ORIGINATION FORM

Proposed Revisions to a Standard Plans Index

Index Number: 715-002

Index Title: Standard Aluminum Lighting

SPREAD FOOTING FOUNDATION OPTION

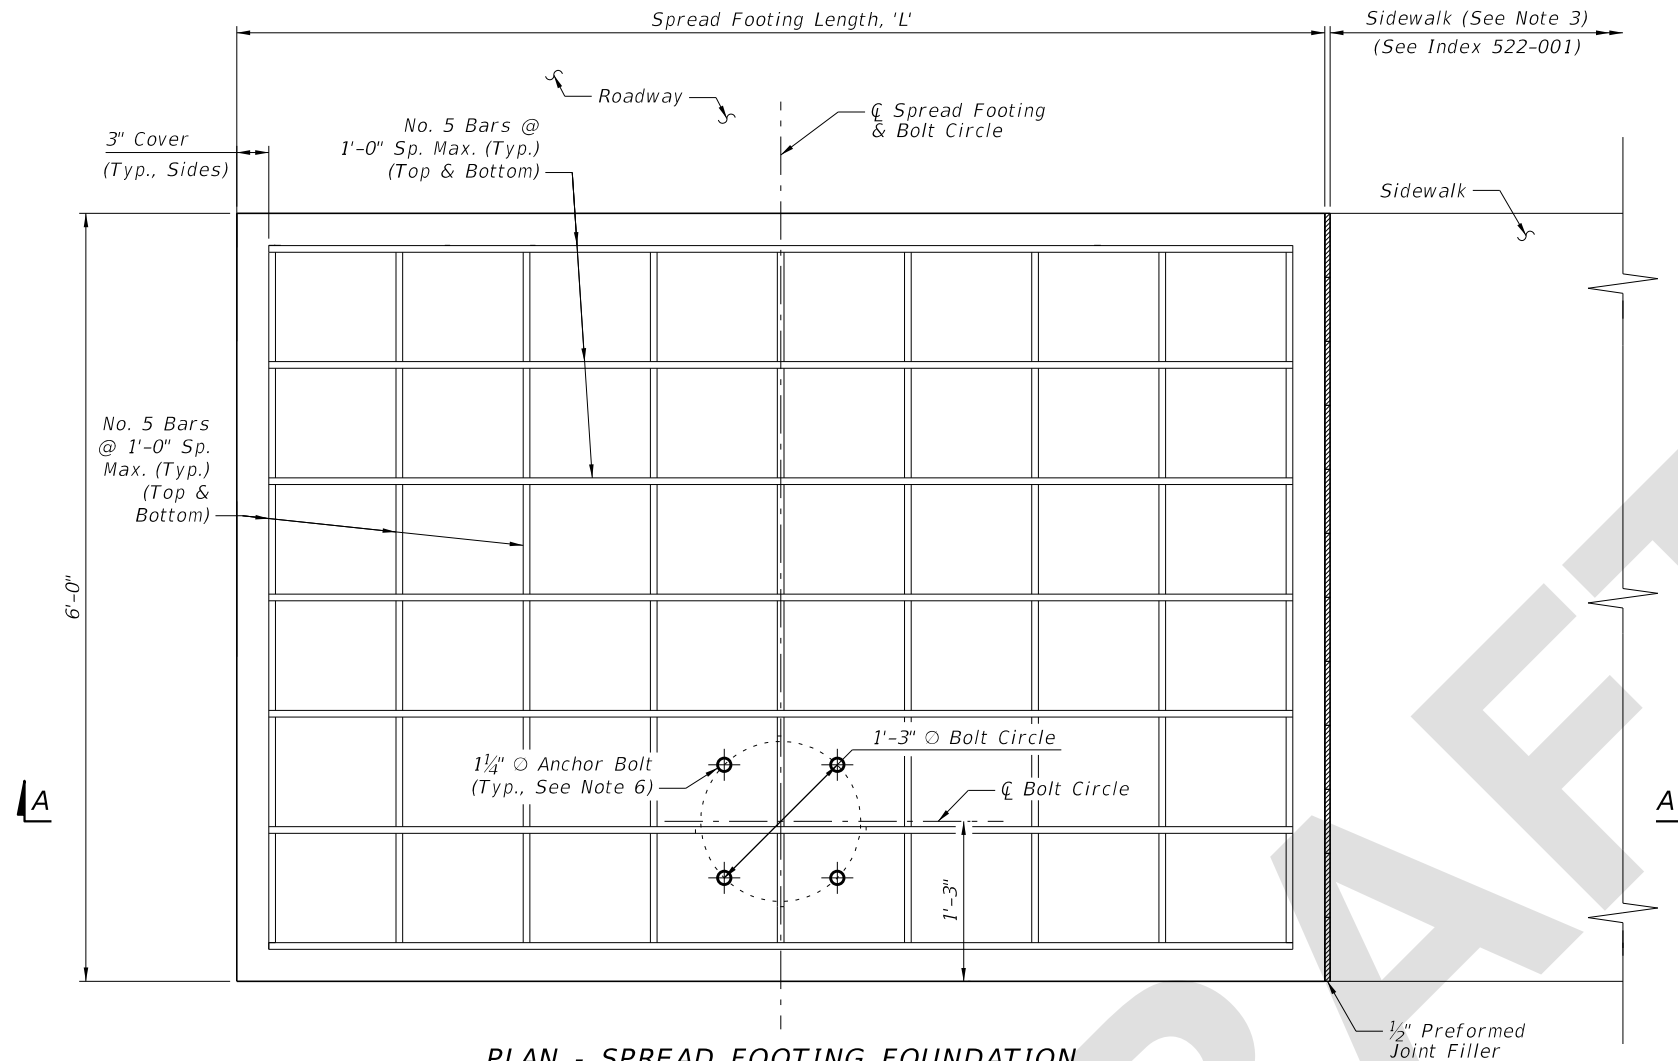
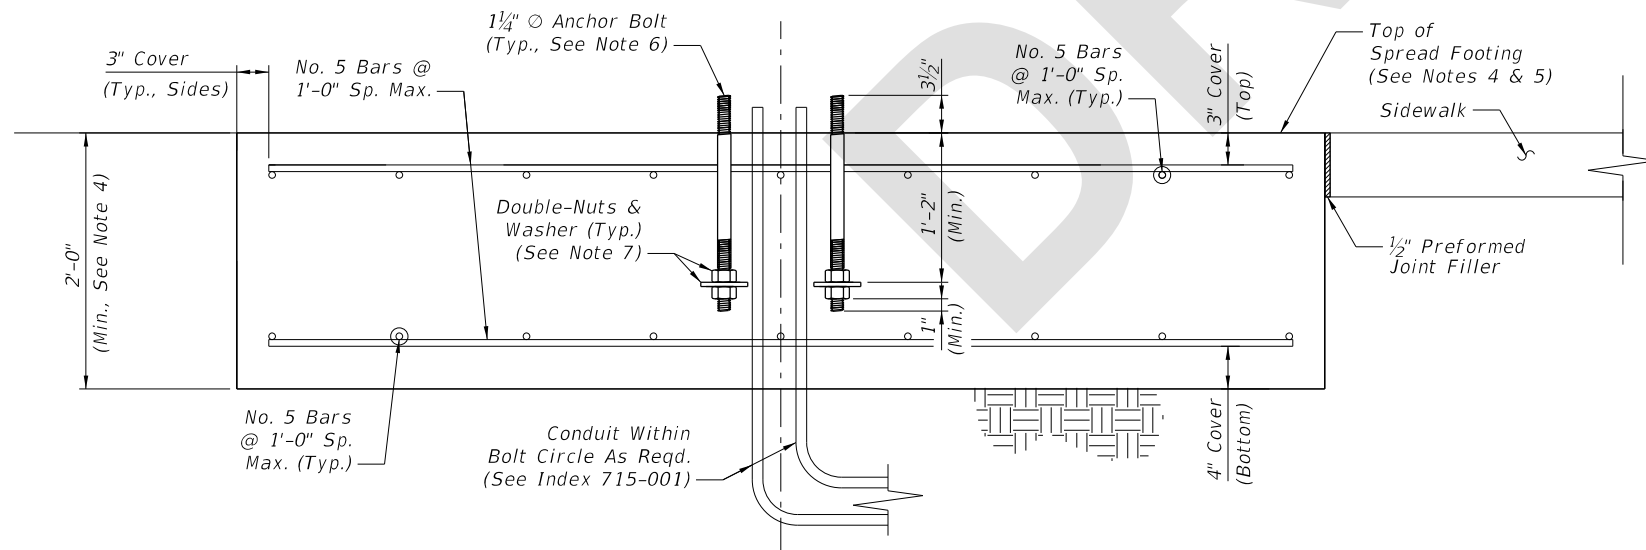
Sheet 5: Added all-new sheet for "Spread Footing Foundation Option".

1. Install the Spread Footing Foundation Option only where called for in the Plans.
2. The Spread Footing Foundation Option is only permitted for use with single arm or top mount light poles. Where applicable, the pole arm must be oriented towards the roadway side of the footing as shown. Double arm configurations are not permitted.

3. Sidewalk placed on the other side or both sides of the spread footing is permitted where shown in the Plans. The sidewalk connection to spread footing requires the 1/2" expansion joint shown regardless of the side.

4. The top of the spread footing must match the cross slope of the adjacent sidewalk where applicable per the Plans. The nominal bottom of the spread footing must remain level.

5. Apply concrete surface finish to the top of the spread footing in accordance with Specification 522-7.
6. Mount the anchor bolts plumb. For the corresponding pole base details, see Sheet 4.

7. Place zinc-plated steel washers with 1 5/16" or 1 3/8" I.D. and a minimum thickness of 1/4". Use either 4" O fender washers or 3"x3" square washers.

8. Where raised curb is called for in the Plans, provide a tooled cold joint with bond breaker between the foundation and back of raised curb. See Sheet 2 and the connection between concrete sidewalk and raised curb per Index 522-001.
